SAFETY EVALUATION BY THE OFFICE OF NUCLEAR REACTOR REGULATION  
PALO VERDE NUCLEAR GENERATION STATION, UNITS, 1, 2, AND 3  
ENGINEERING BRANCH  
DIVISION OF PWR LICENSING-B

PALO VERDE MASONRY WALL EVALUATION

FIGURE 2

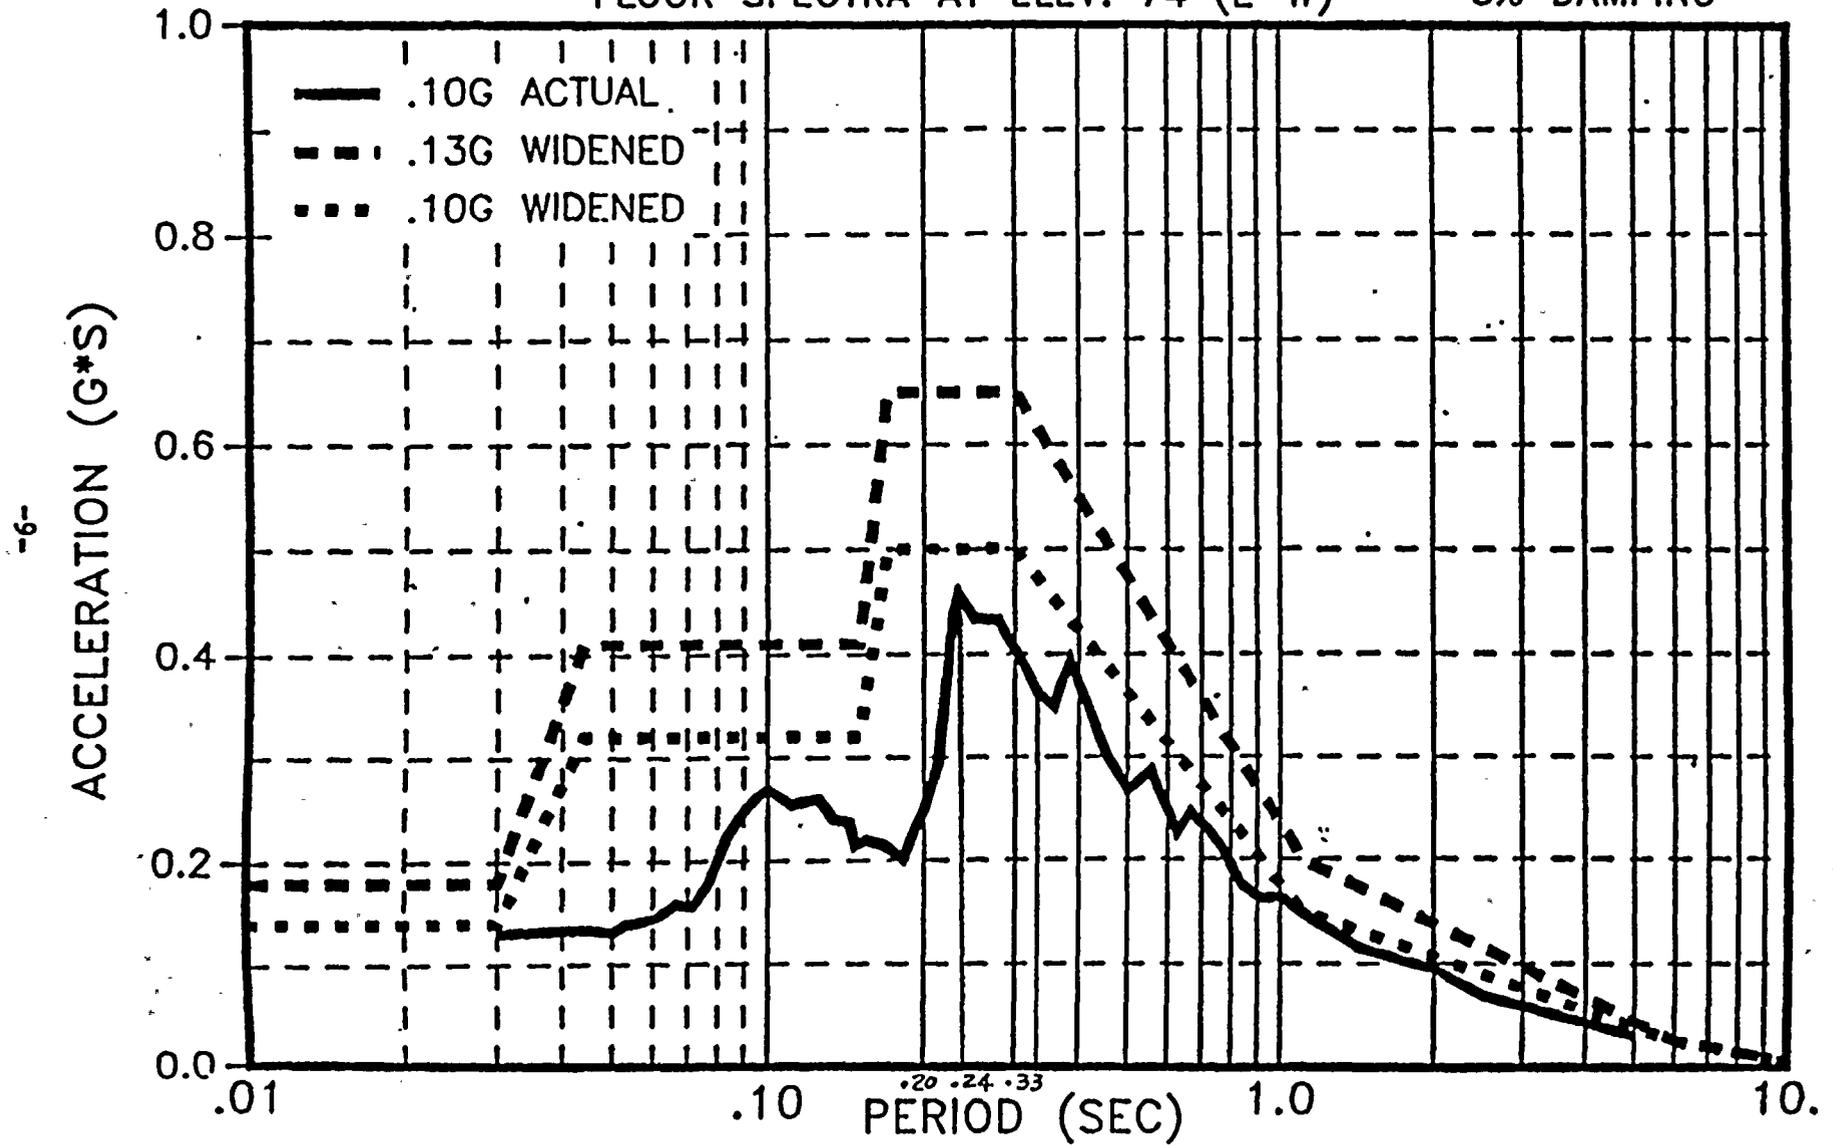
The process from an estimated  $I_e$  to stresses in a wall during an earthquake can be best illustrated by using the response spectra, as shown in Fig. 2 of the June 19, 1986 report, which is attached at the end of the text. When  $I_e$  was calculated using the ACI code method, the frequency of the wall at elevation 74 feet subjected to SSE became 3.03 cps (Reference 4), which corresponds to a period of 0.33 second, and at this period the wall would experience the near maximum acceleration and stress, as the response spectra represented by the solid line indicated in Fig. 2. However, if  $I_e$  was calculated using the Bechtel method, the frequency of the same wall subjected to the same SSE became 4.88 cps (Reference 5), which corresponds to a period of 0.2 second, and at this period the wall would experience the near minimum acceleration and stress, as the response spectra indicated in Fig. 2.

Therefore, the ACI code method would yield a conservative value of  $I_e$  for the wall at elevation 74 feet even if the actual  $I_e$  of the wall were substantially different from the calculated  $I_e$ . However, the Bechtel method would yield a nonconservative value of  $I_e$  should the actual  $I_e$  be different from the calculated  $I_e$ .

benchmark the adequacy of the Bechtel method. Since the frequency of the wall at elevation 74 feet during SSE was calculated to be 3.03 cps by using the ACI code method and 4.88 cps by using the Bechtel method, the ratio in frequencies between the two methods is 1.61. This is equivalent to a ratio of 2.59 in the values of  $I_e$  between the two methods, because  $I_e$  is a square function of frequency. The Bechtel method of establishing  $I_e$  overestimates the wall stiffness by a factor of 2.59 in comparison with the ACI code value. It must be pointed out that the mathematical model of estimating  $I_e$  in the Bechtel method is not an established method and has not been benchmarked by laboratory tests. Had Bechtel compared its computed deflections using its method of estimating  $I_e$  with the measured deflections of those controlled laboratory test data used by ACI Committee 435, Bechtel would have found that its computed deflections had been substantially lower than measured deflections.

The previous paragraph has discussed the inadequacy of the Bechtel method in estimating  $I_e$ . This paragraph discusses an evaluation consideration that is necessary but has not been considered in the June 19, 1986 report. ACI Committee 435 also reported in Reference 6 that "...a variety of factors may be known or estimated in the laboratory that are unknown in the design situation. Because of these uncertainties, the variability of deflection between actual field and calculated deflections can be expected to be greater than the variability of deflection between actual laboratory and calculated deflection. Therefore, the results of the analysis reported in this report must be viewed as minima rather than average or expected values. Greater variability would most likely be obtained if field data were used instead of laboratory data." As previously discussed, the main reason that Bechtel could reduce the calculated bond stresses substantially in the June 19, 1986 report from those in the previous report was due to the fact that the period of the wall at elevation 74 feet had been tuned to 0.2 second by using the Bechtel method in estimating  $I_e$  instead of 0.33 second by using

the ACI code method. In view of the range of variability of the actual field  $I_e$  against the assumed  $I_e$  in design calculation as stated by the ACI Committee 435, some variation of  $I_e$  must be considered in the analysis. If a variability in  $I_e$  of 40% is considered, the period of 0.2 second of the wall at elevation 74 feet would become 0.24 second. It can be seen from the response spectra in Fig. 2 that the wall could experience from the near minimum acceleration and stresses at the period of 0.2 second to the maximum acceleration and stresses at the period of 0.24 second within a variability in  $I_e$  of 40%. This was not considered in the June 19, 1986 report.

Based on the review of the information submitted by the licensee and the reasons as stated and discussed above, the staff has concluded that strengthening the walls at elevation 74 feet is required.
